Accessibility Report

20-22 Atchison St
St Leonards, NSW

Report No: 25056-201-R01 Access Report
Revision: 02
Date: 22 September 2025

Drawing Title: **ADAPTABLE & LIVEABLE SILVER UNITS - SHEET 3**

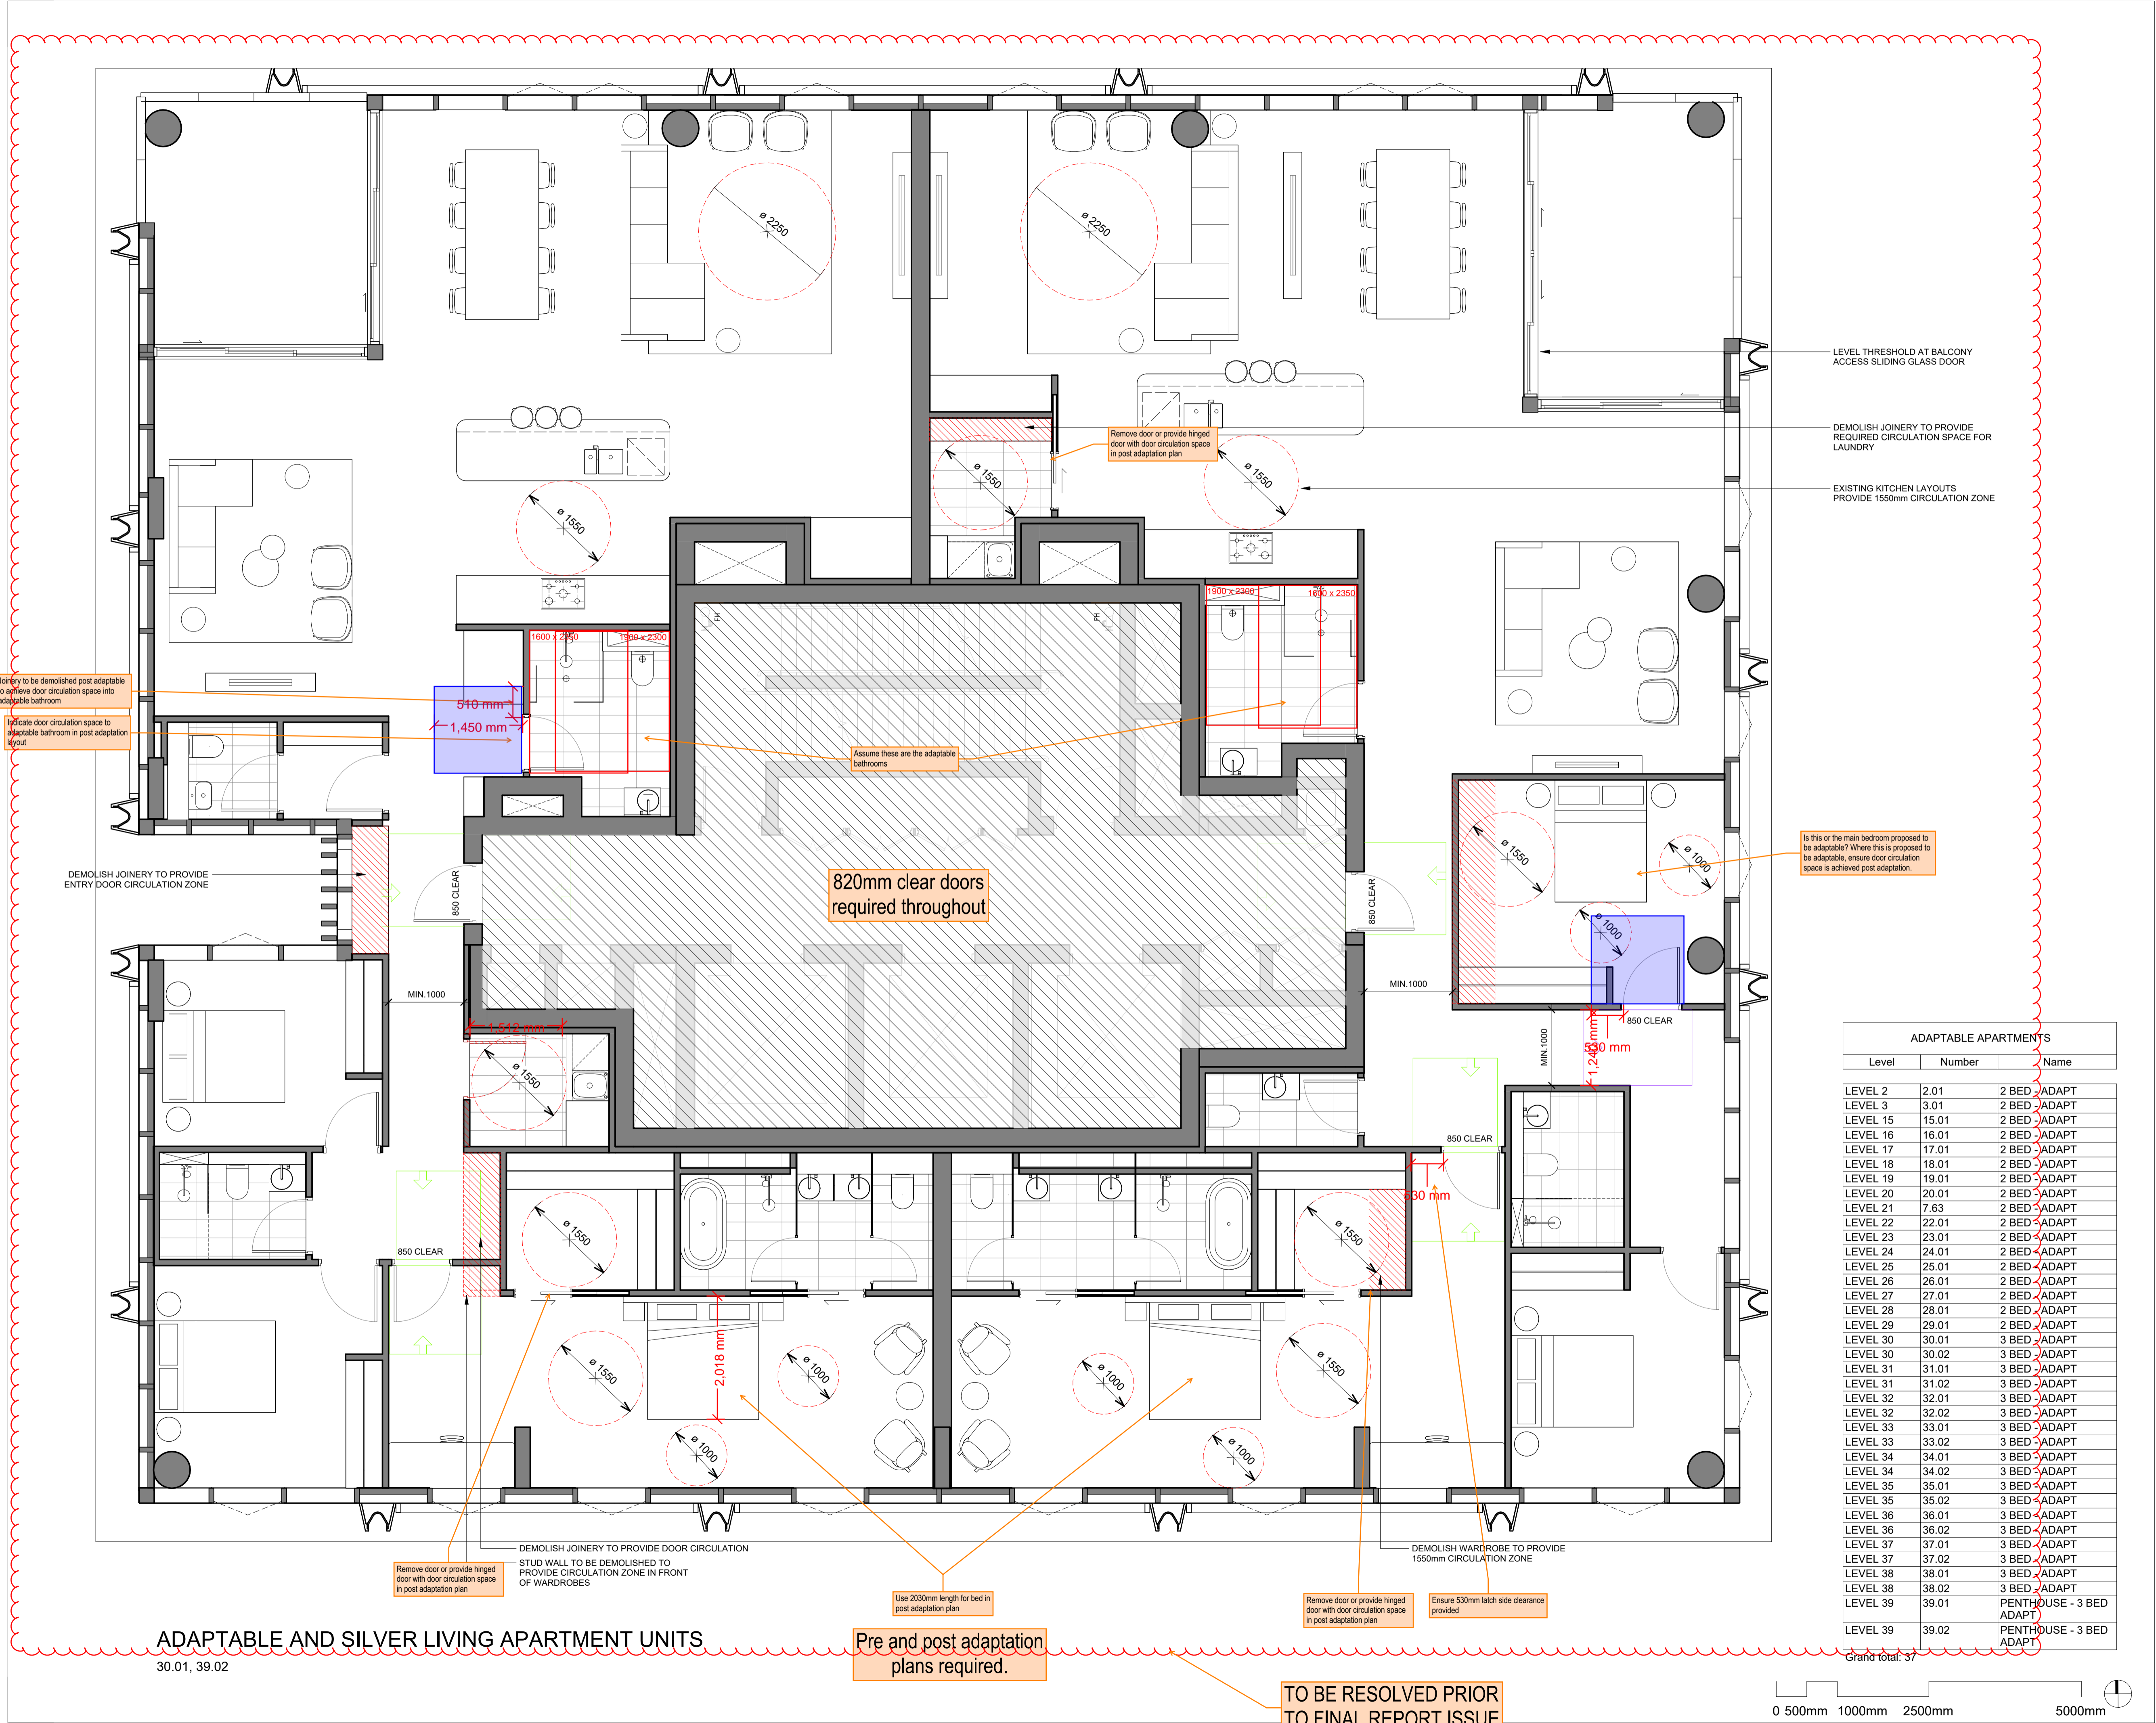
Pre and post adaptation plans required.
